NEW DEVELOPMENT FOR:
JOHNSON TOWNHOMES
 33RD ST., GARDEN CITY, ID. 83714

Code Waiver Request PUDFY2021-0010

Re: **Planned Unit Development for the Johnson GC Townhome Project**
Located at: Lot 9, 10, 11, Block 33, Fairview Acres Sub No.5
E 33rd St., Garden City, ID 83714

City Comment Response PUDFY2021-0010

SHEET NUMBER
A-4.0

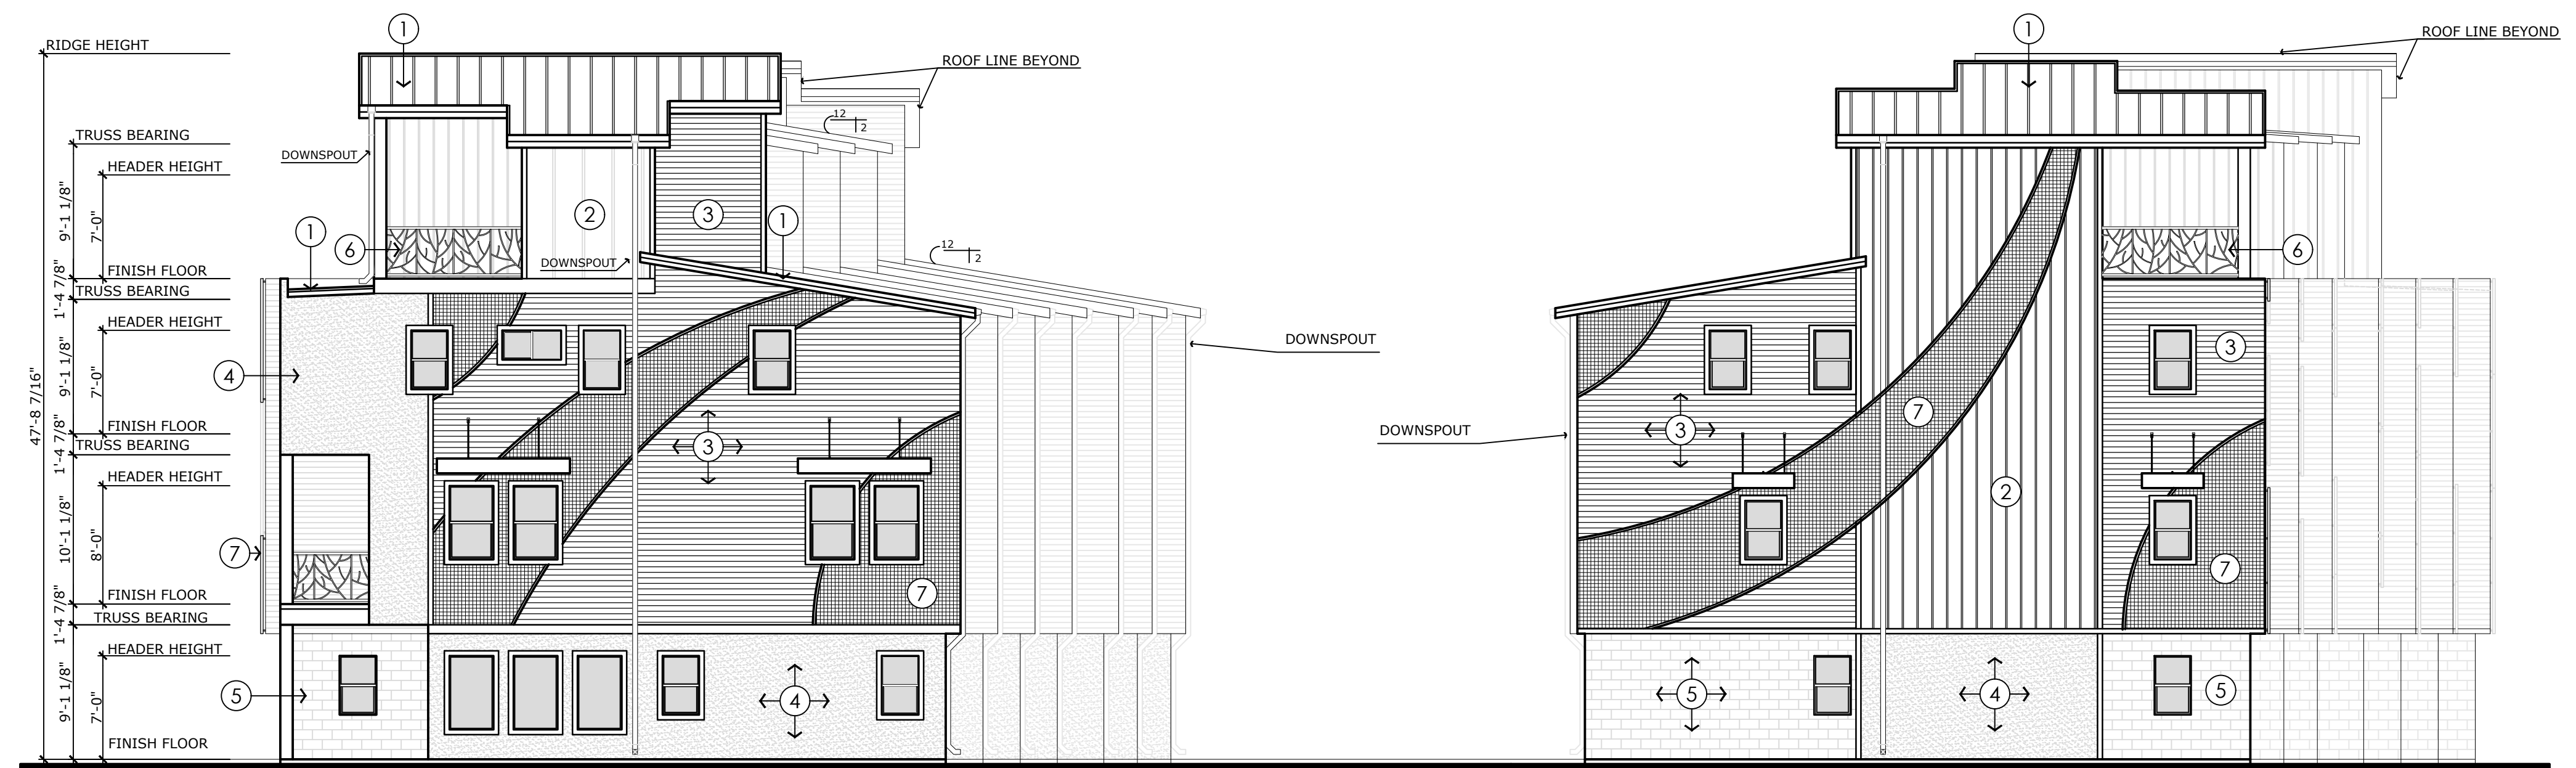
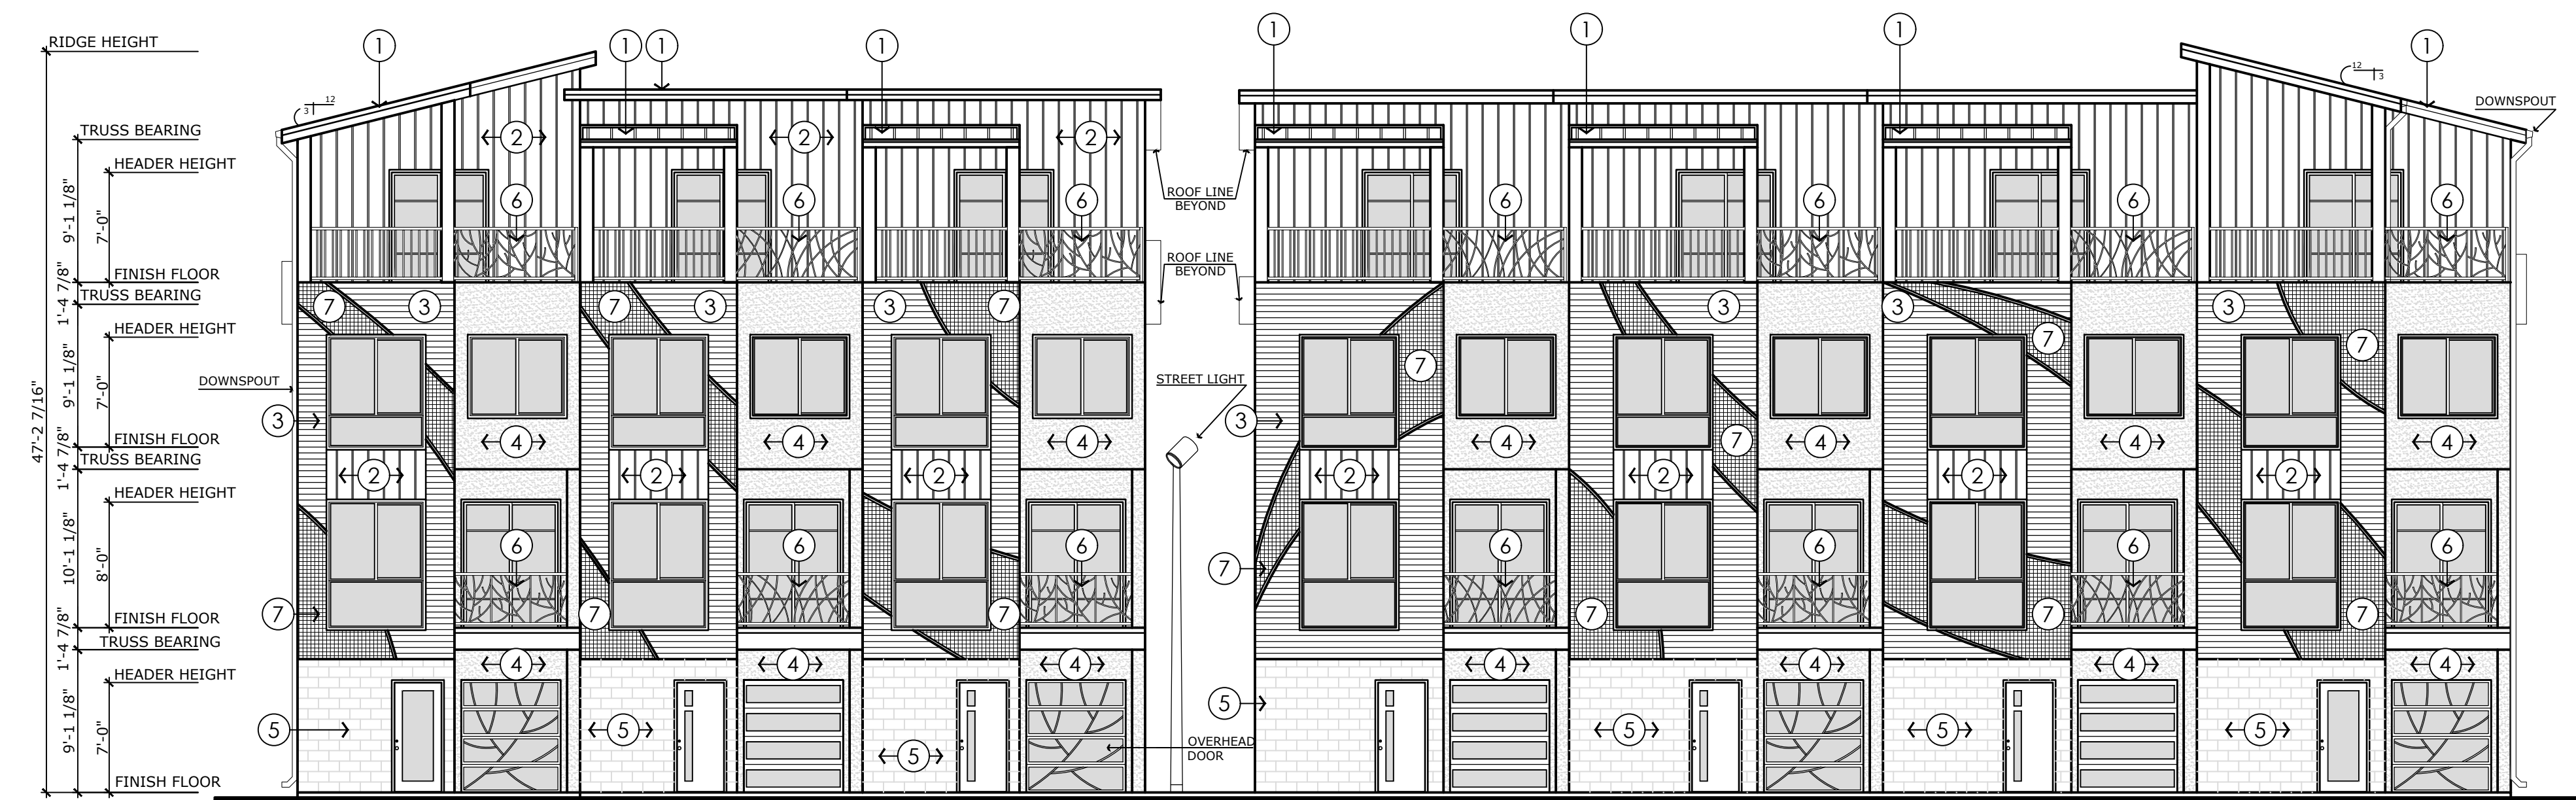
We are requesting a code waiver change the rear setback from 5' to 3'-11 ½". Reducing the rear setback will allow for a 7' wide pathway between the homes. This will lead to a better pedestrian experience and connectivity. The pathway connects the homes to 33rd street and also provides access to the common space to the Northwest side of the property. Additional architectural features have been added to the Southwest facade to increase the aesthetic. These features include varying materials, wire mesh accents and a public art wall the corner nearest to 33rd St. Please see revised Site Plan on sheet A-1.0., and Elevations on sheet A-4.0 and 4.
